May 28, 2009

Subject: Comments on GRU January 30, 2009 Technical Memorandum entitled “*Evidence of DNAPL Movement at Koppers Site,*”

ATTACHMENT 1
DETAILED RESPONSE TO GRU TECHNICAL MEMORANDUM
“EVIDENCE OF DNAPL MOVEMENT AT KOPPERS SITE, JANUARY 30, 2009”

Figure 4. HG-15S -- Linear regression of DNAPL thickness versus recovery volume.

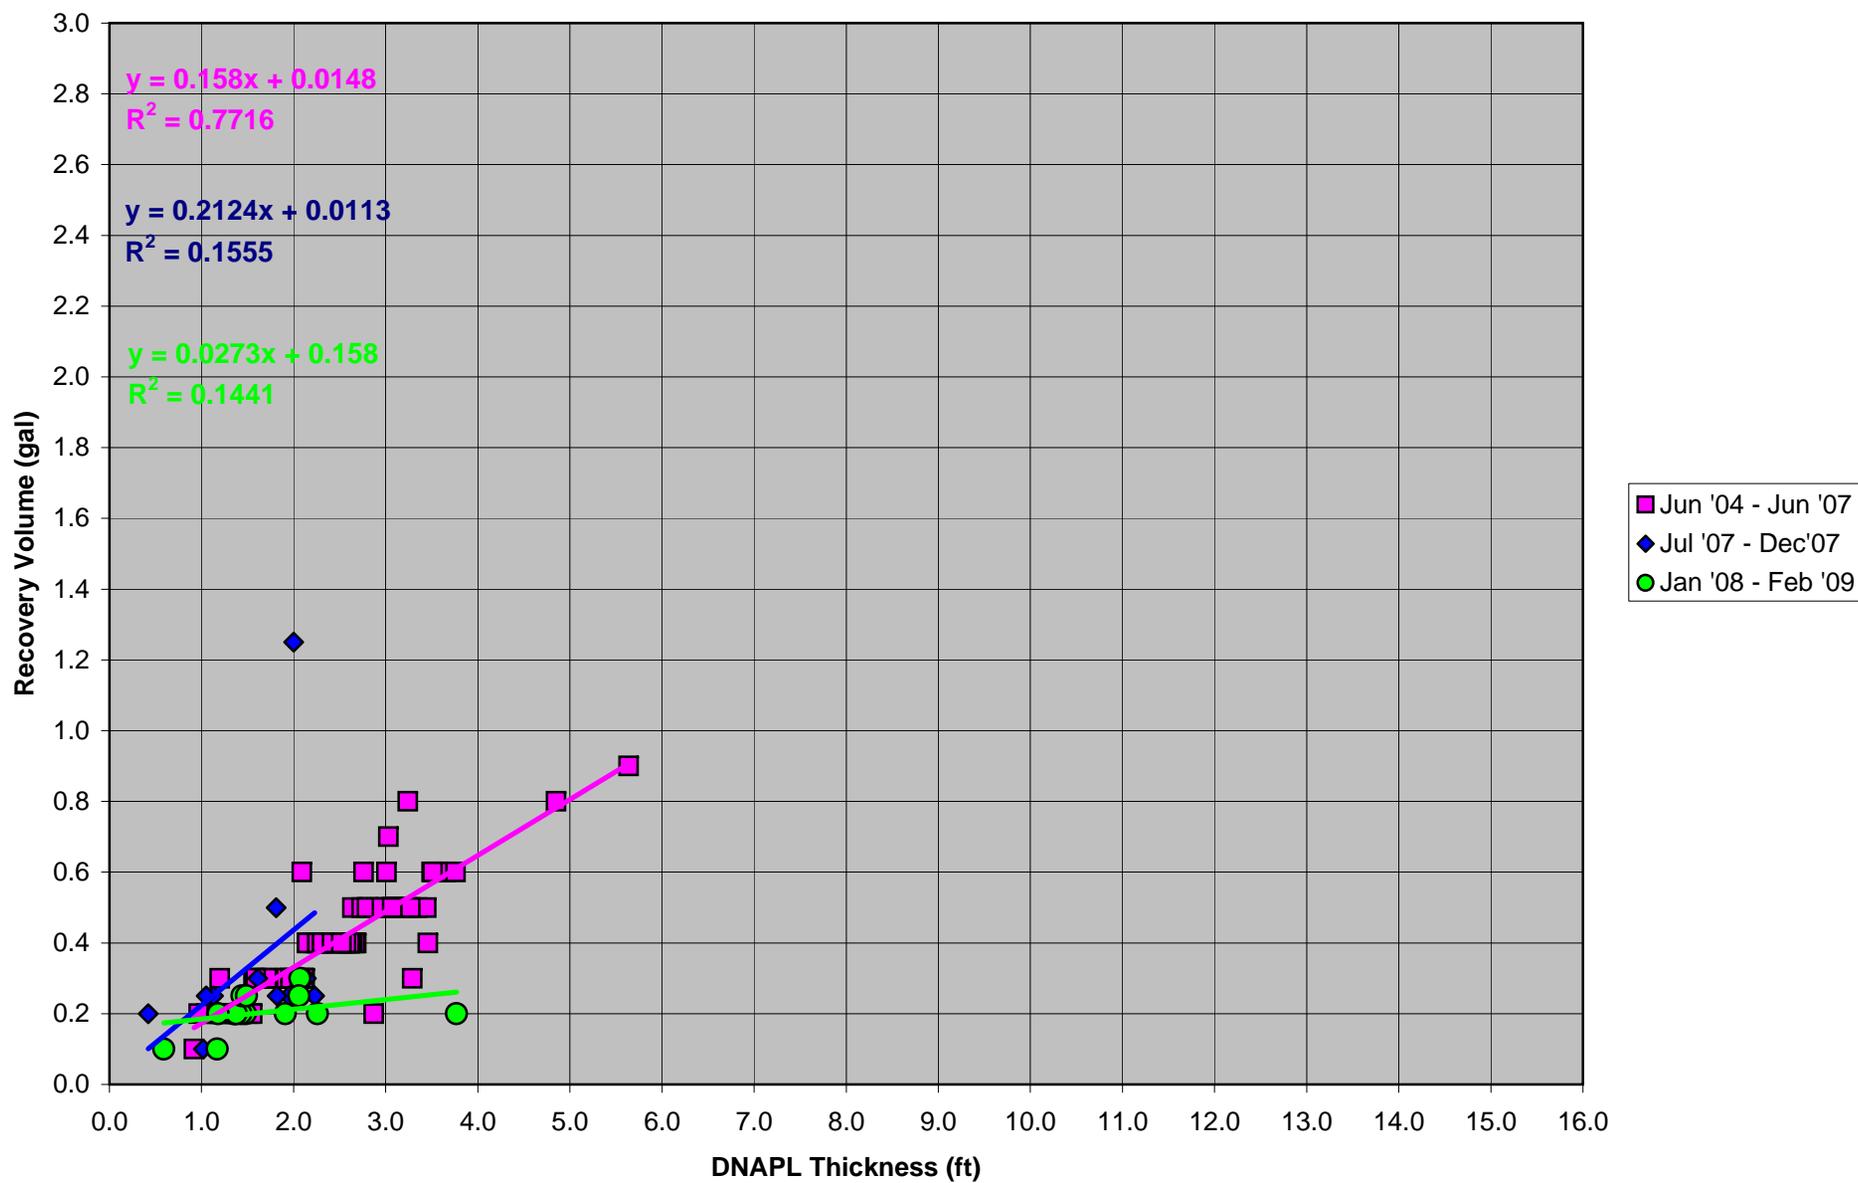
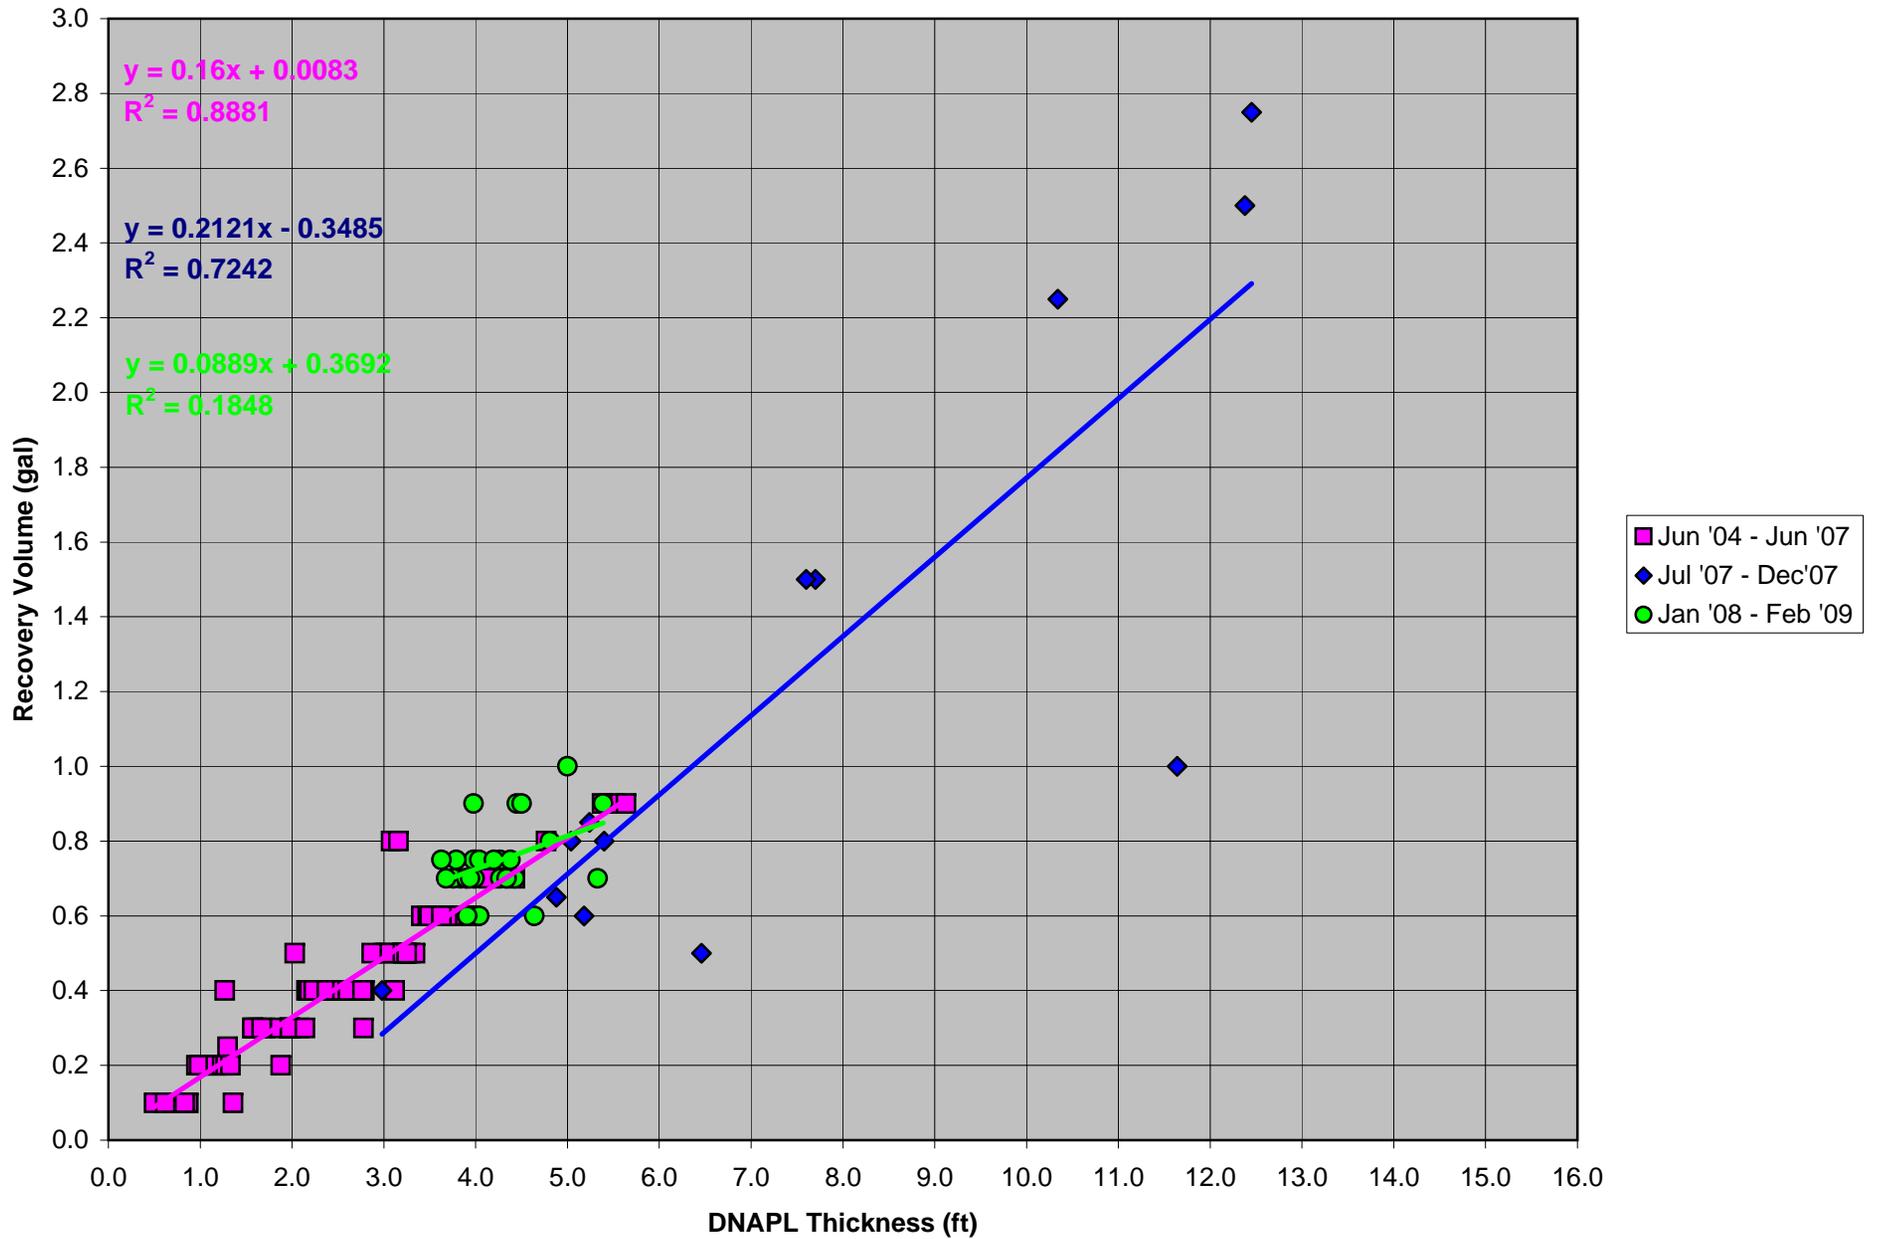
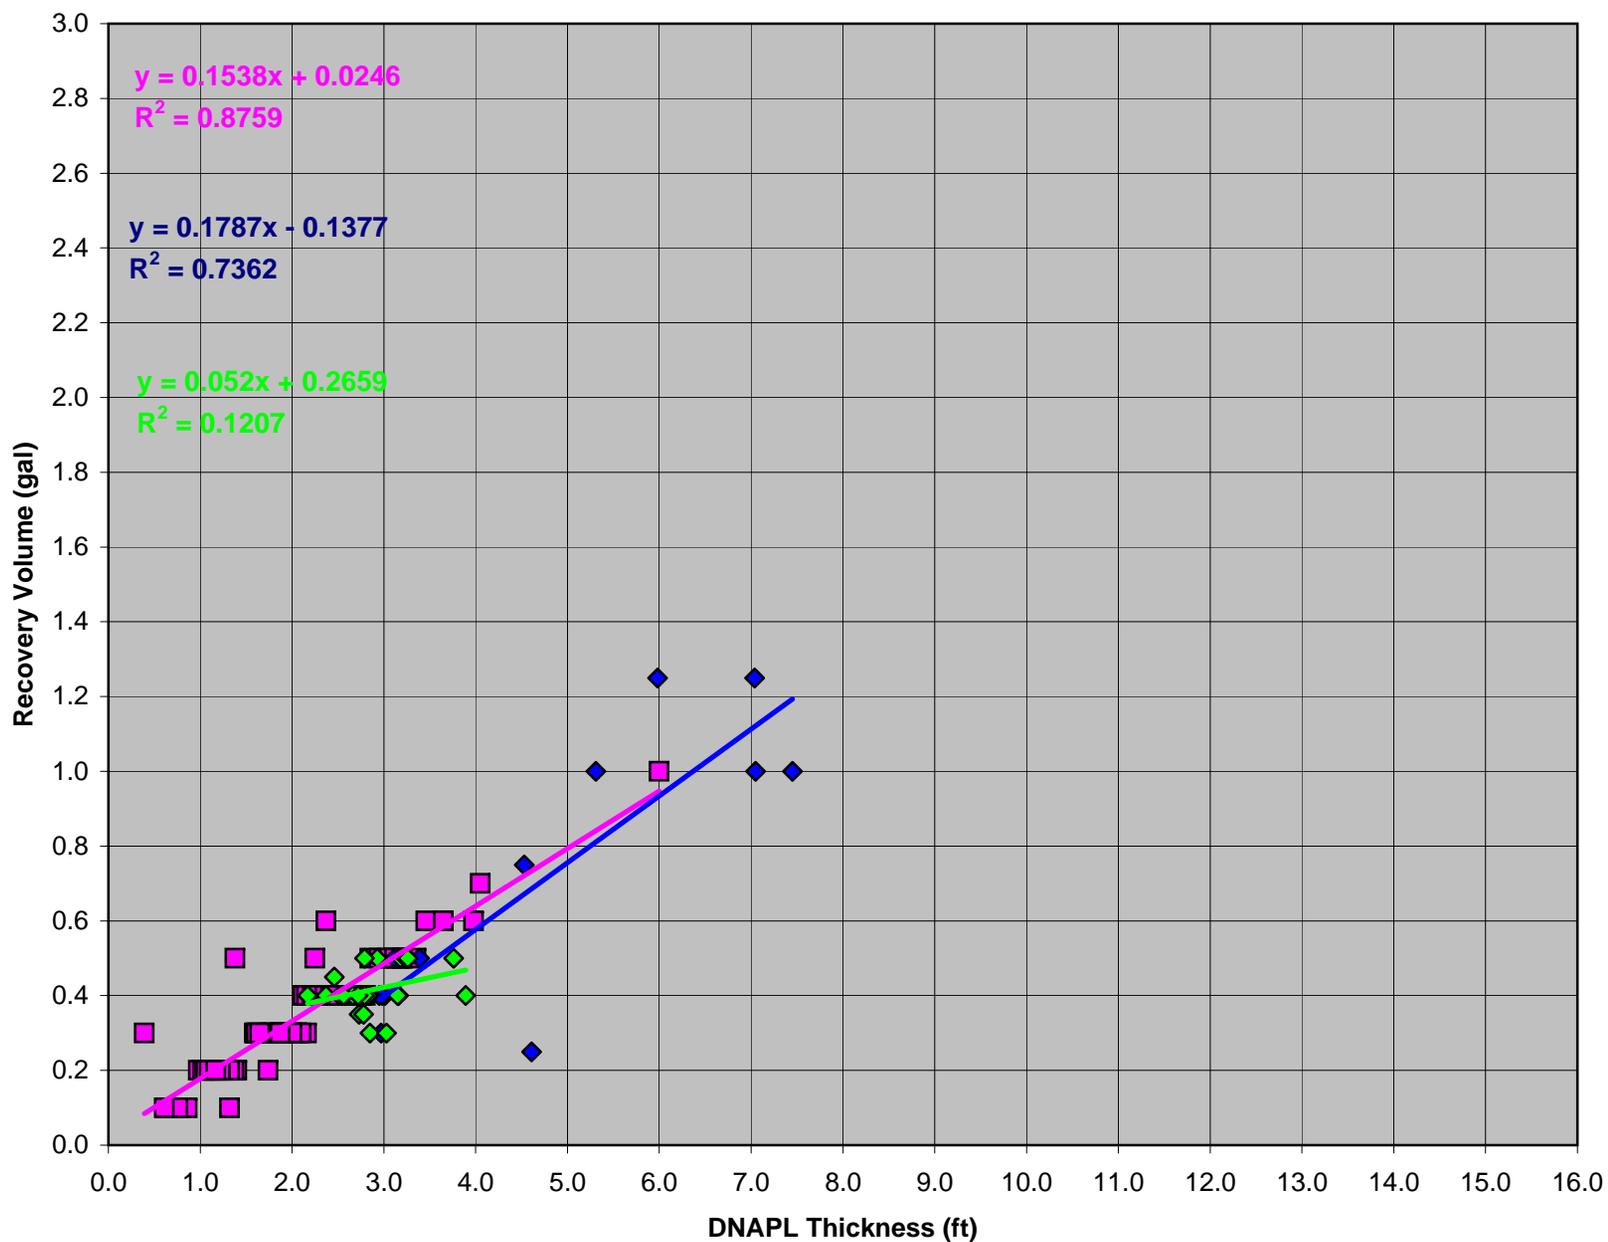
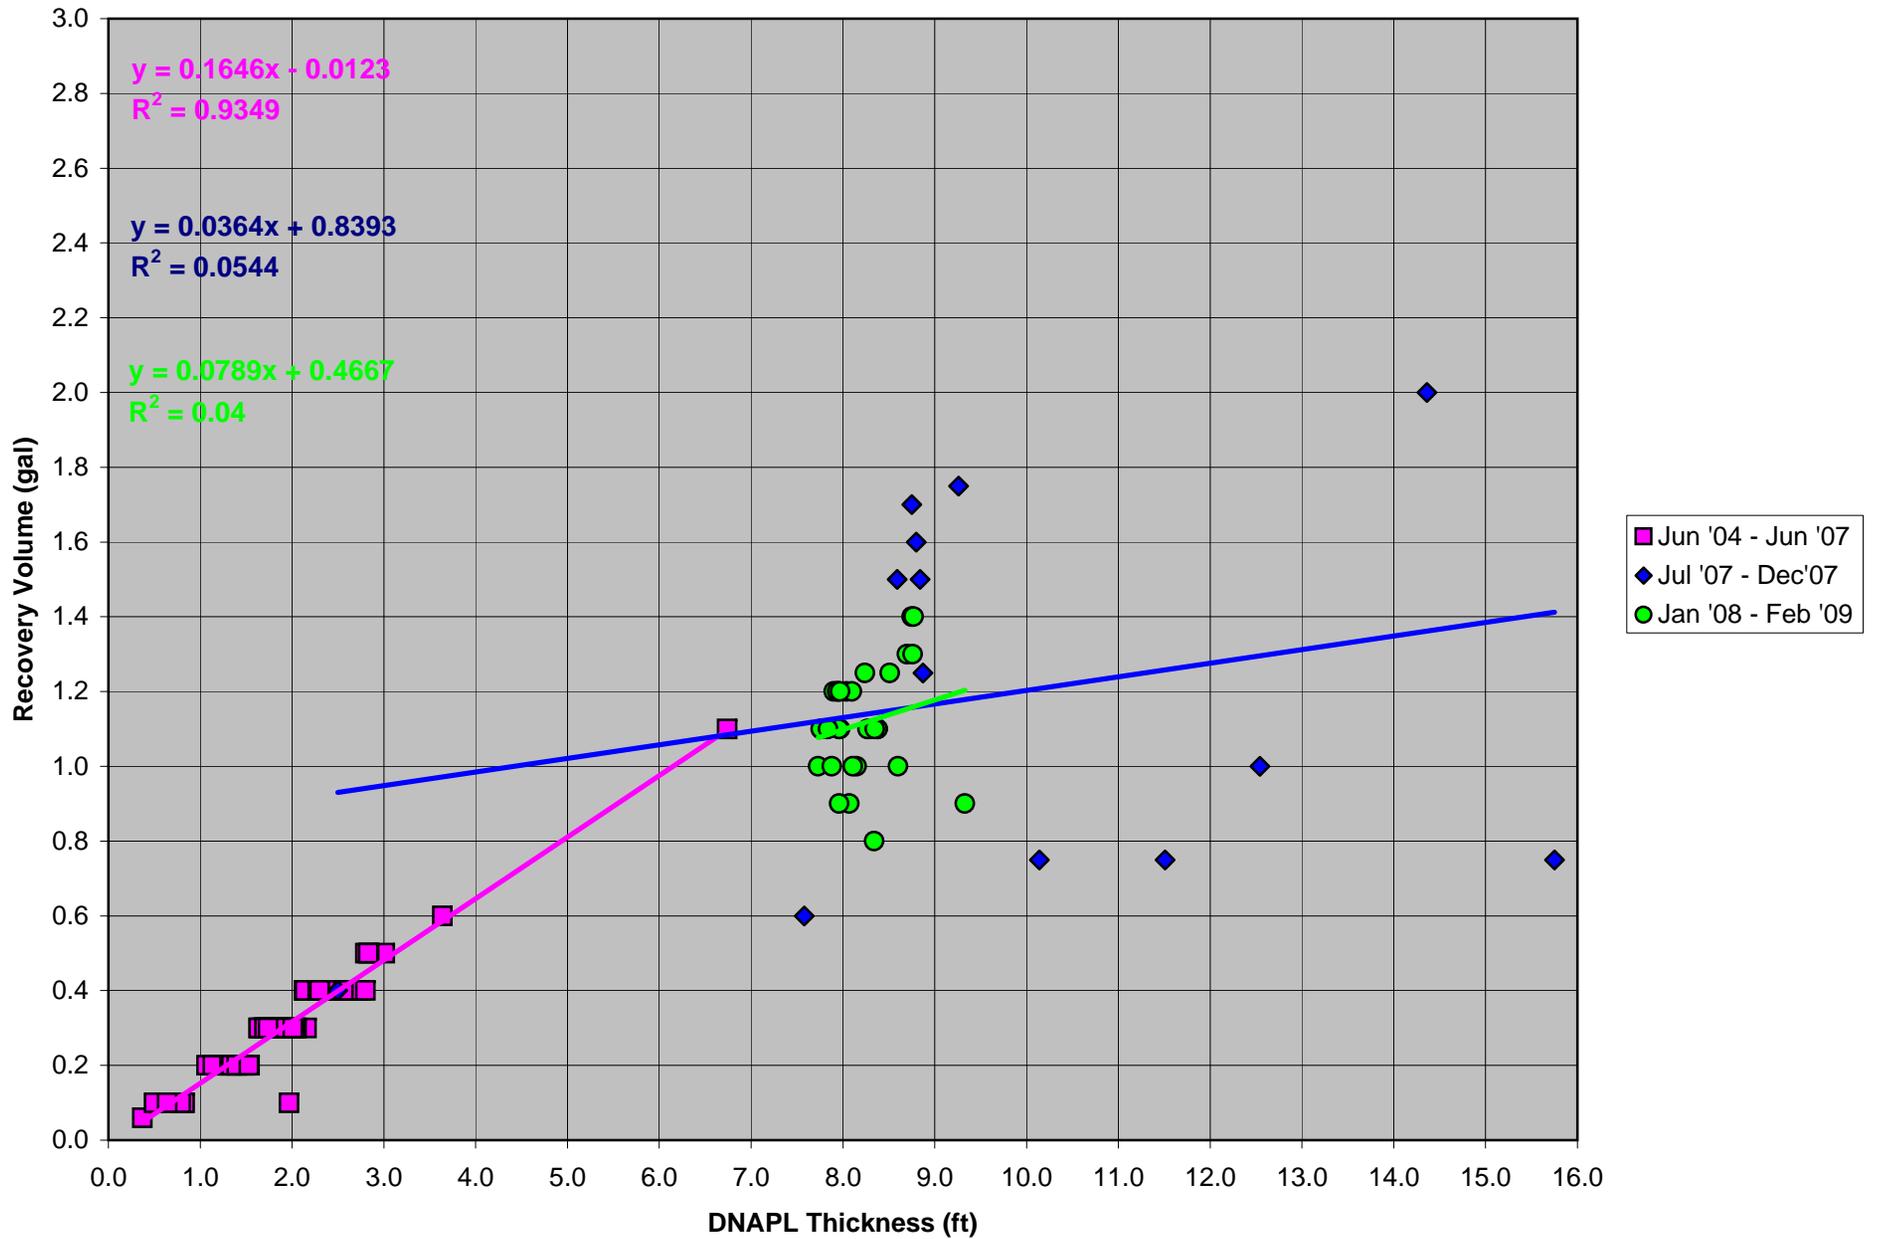
select wells appears reasonable prior to December 2007, a consistent time period when data for the majority of the wells appeared reasonable was chosen for the analysis. **Figures 1 through 5** show a plot of DNAPL thickness versus recovered DNAPL volume for wells HG-10S through HG-16S, respectively.

The linear regression of DNAPL thickness versus recovered volume for each of the five HG DNAPL wells for the time period July to December 2007 is poorly correlated and not consistent with pre-July 2007 data. The R^2 value for these data ranged from 0.05 to 0.74, with an R^2 value of less than 0.35 for three of the five wells. An R^2 value of 0.05 (HG-15S) basically indicates that there is little correlation between the measured thicknesses and recovered volumes. Note that the reported increase in DNAPL thicknesses and recovered volumes for well HG-15S is the primary basis for the current GRU conceptual model of on-going DNAPL mobility.

The linear-regression coefficient for feet of DNAPL in the well versus recovered volume ranged from 0.036 to 0.21, indicating that recovered volumes of DNAPL versus measured thicknesses were highly variable between wells and inconsistent with pre-July 2007 data. Well HG-15S had the lowest regression coefficient of 0.036, indicating that for every foot of DNAPL measured in the well, only 0.036 gallons of DNAPL were recovered. This is a physical impossibility given that at a minimum there should be 0.162 gallons of DNAPL for every foot of DNAPL in a 2-inch well. If additional DNAPL is contained in the filter pack outside of the screen, the volume could be greater than 0.162 gallons. Hence, the linear regression coefficient for data collected during this time period (July-December 2007) indicates that either the reported thicknesses and/or recovered DNAPL volumes are inaccurate for HG-15S. The regression analyses for the remaining four wells indicate similar issues with data collected during this time period (see **Figures 1** through **5**).

The R^2 values for January 2008 to February 2009 data range from 0.04 to 0.205. Again, the lowest R^2 value of 0.04 for this time period was for well HG-15S. This is consistent with the plotted data points (**Figure 4**) where the recovered DNAPL volumes vary considerably for the same approximate DNAPL thicknesses measured during this time period. The low R^2 values for the data collected during this time period indicate a poor correlation between measured thicknesses and recovered volumes. However, with the exception of HG-15S, the majority of the DNAPL thicknesses and recovered volumes are within the range of thicknesses measured pre-July 2007. The low R^2 values for this subset of data are partially due to the fact that the thicknesses and recovered volumes for each of the wells are not changing much over this time period. Because of the narrow range of data values, small inaccuracies in these measurements results in a lower R^2 value, even though the data appear to be reasonable on the plots.
